Subject: Submittal of the Work Plans for the Plugging and Abandonment of Wells and Boreholes for Fiscal Year 2019, Revision 1

**Cross-Reference of NMED NOD Comments and
Revisions to the Work Plans for the Plugging and Abandonment of Wells and Boreholes for Fiscal Year 2019**

**Response to Notice of Disapproval Work Plans for the
Plugging and Abandonment of Wells and Boreholes for Fiscal Year 2019,
Dated November 2018**

Figure 2.5-1 Locations of alluvial groundwater observation wells in Sandia Canyon

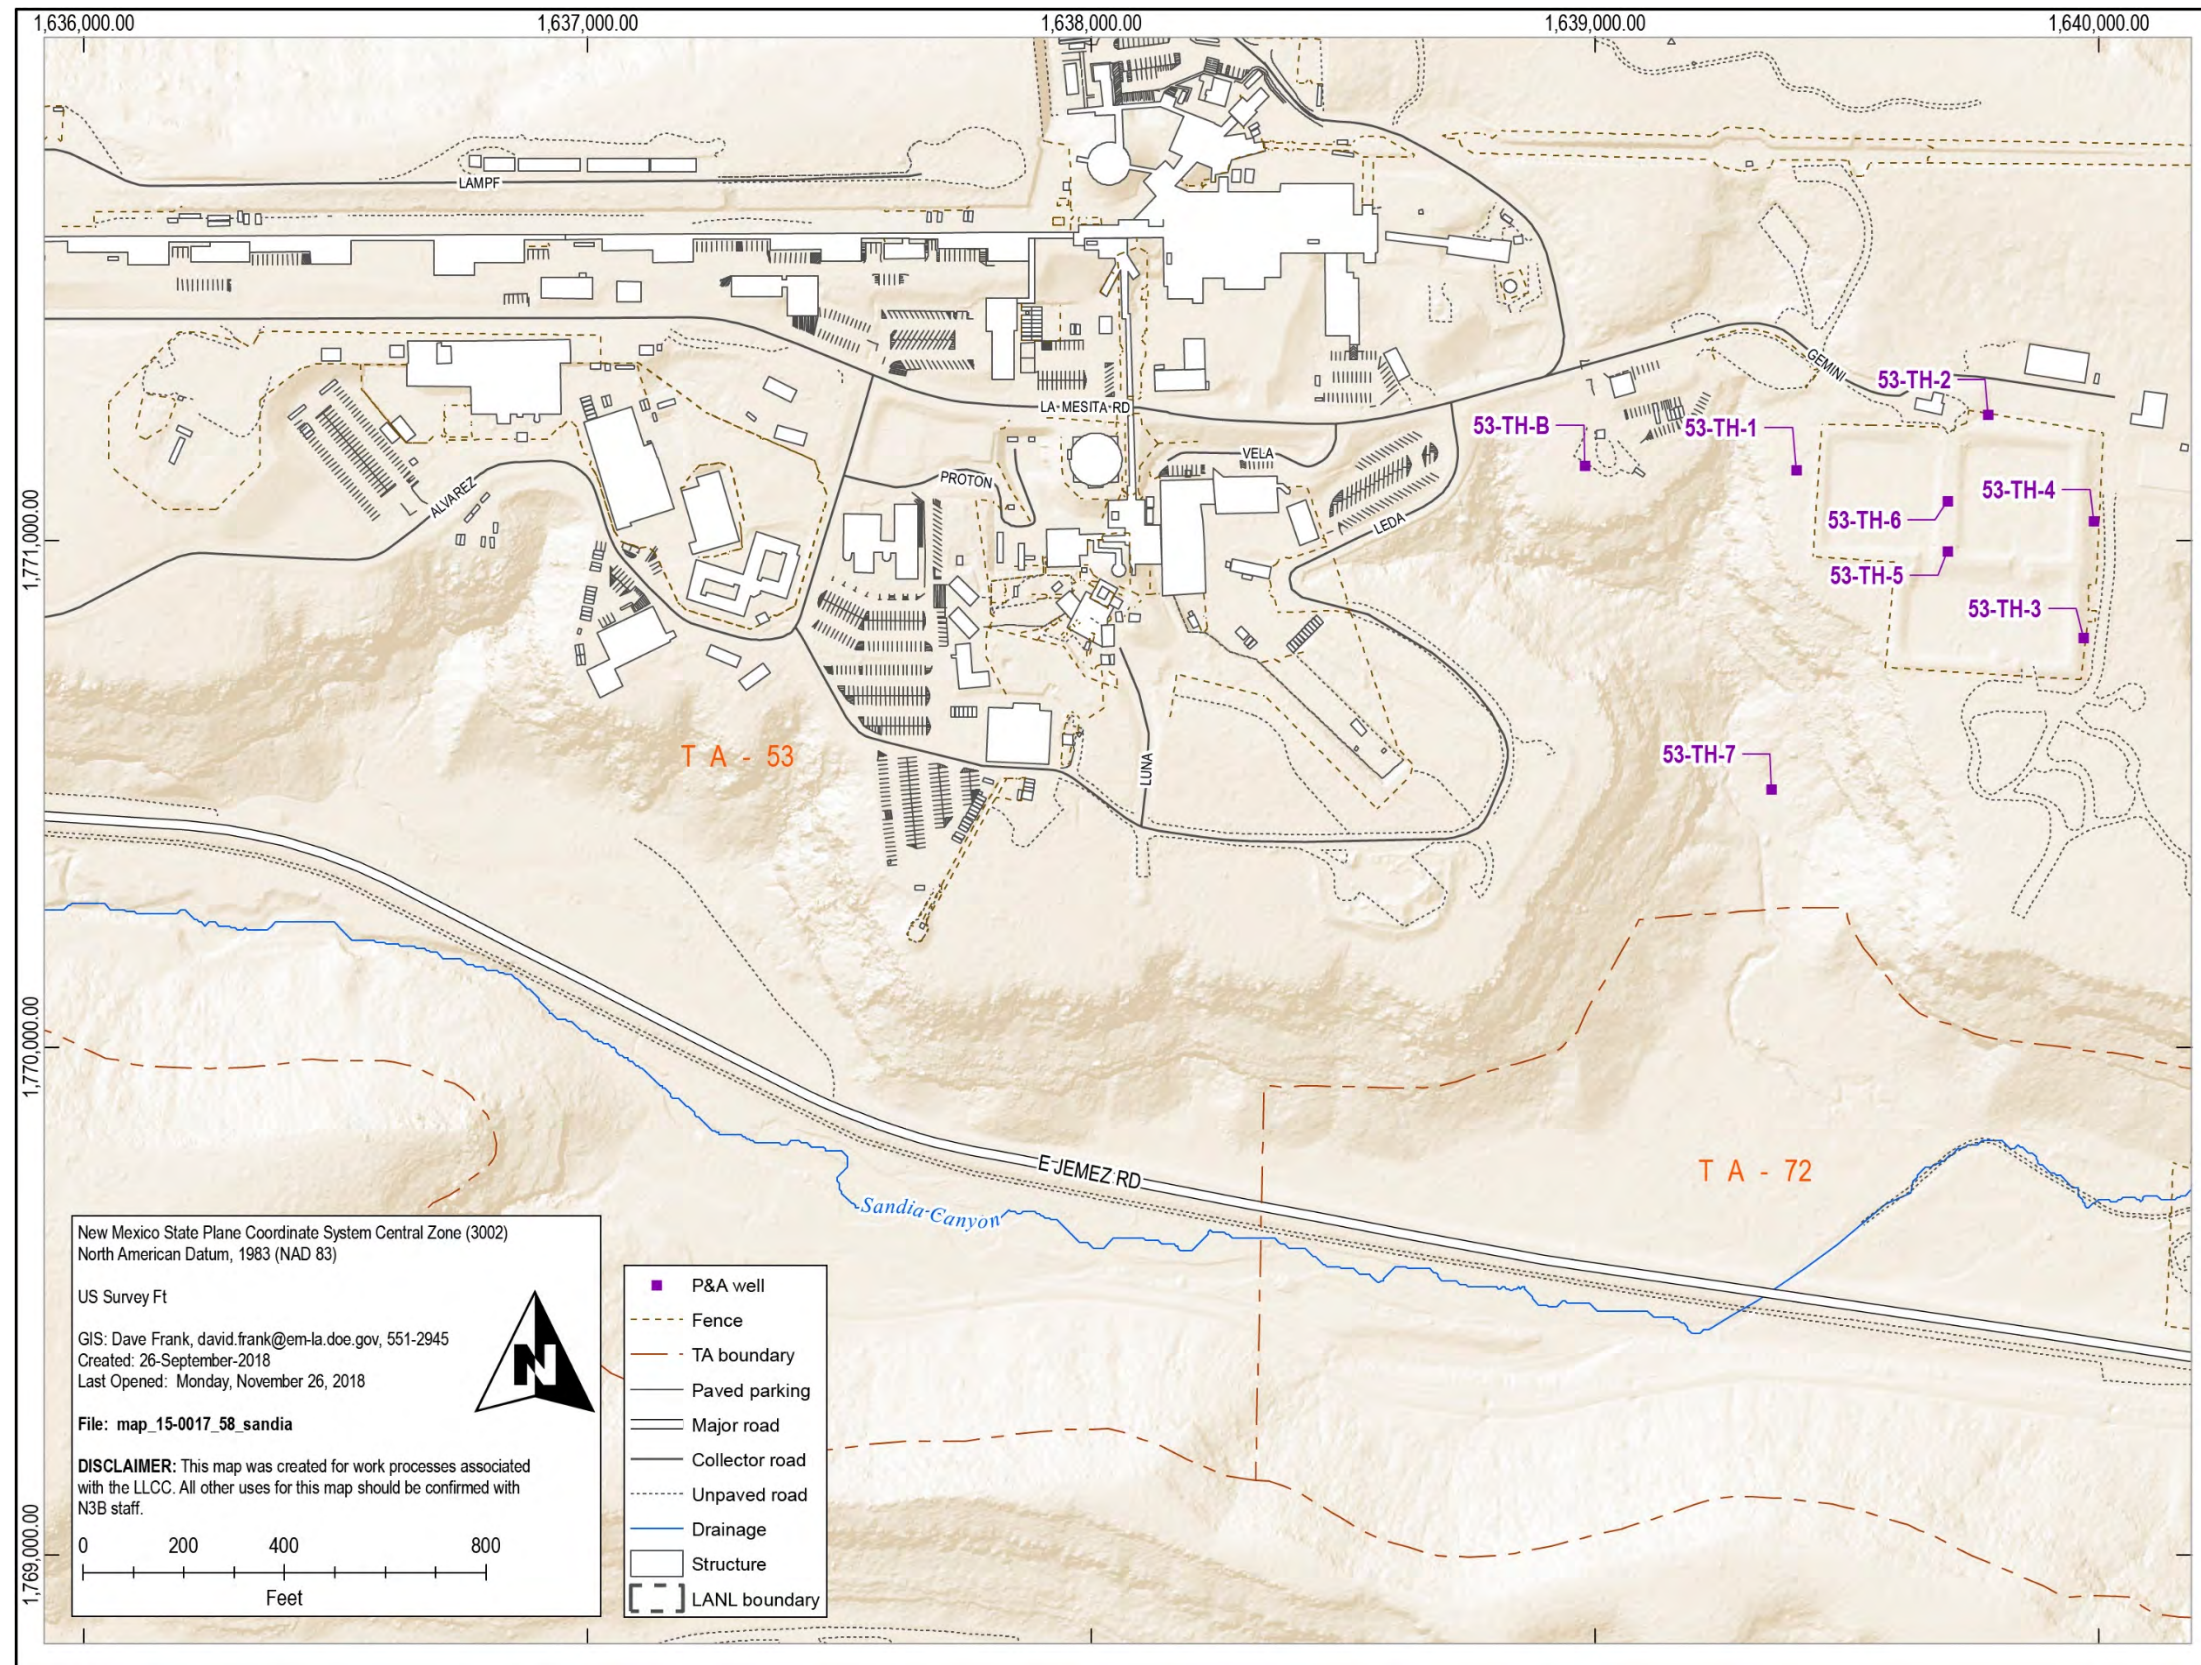
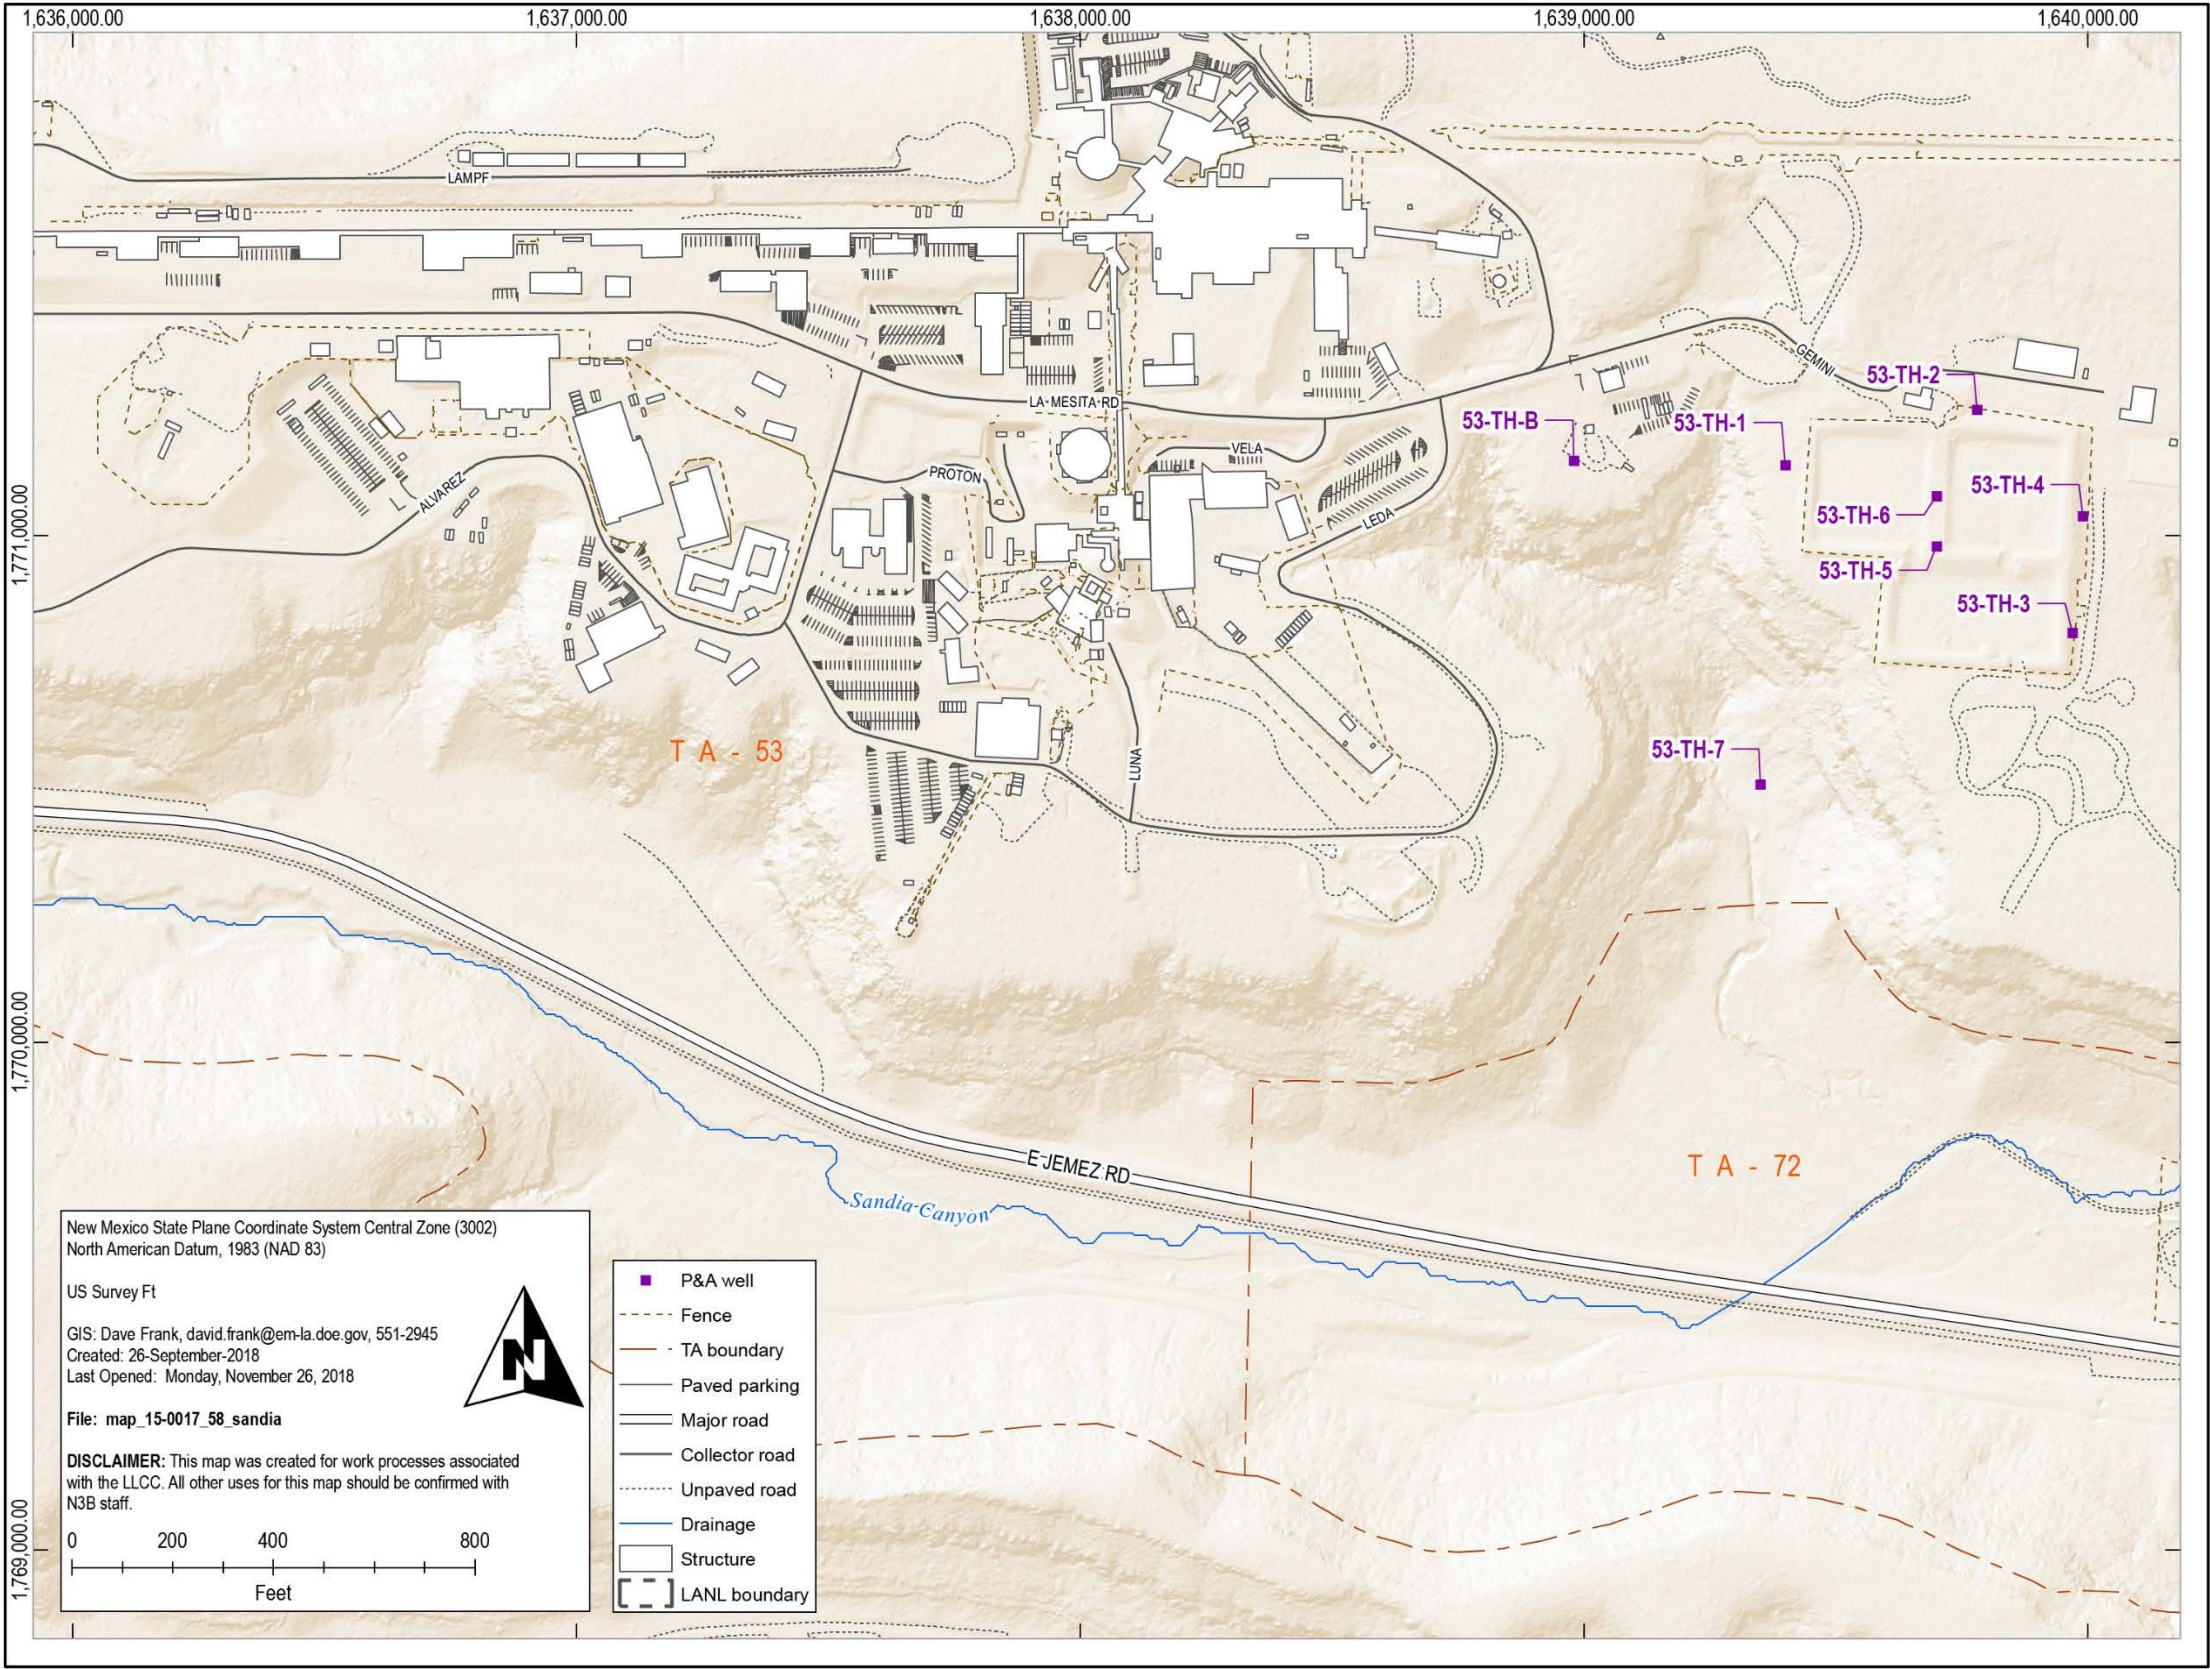
- 2. Section 3.5, Work Plan to Plug and Abandon Alluvial Groundwater Test Boreholes in Sandia Canyon, page 8:**

2. Language has been added to section 2.5 to address the presence of groundwater and associated contaminants. The current status of PRS 53-002 (a,b) has been addressed.
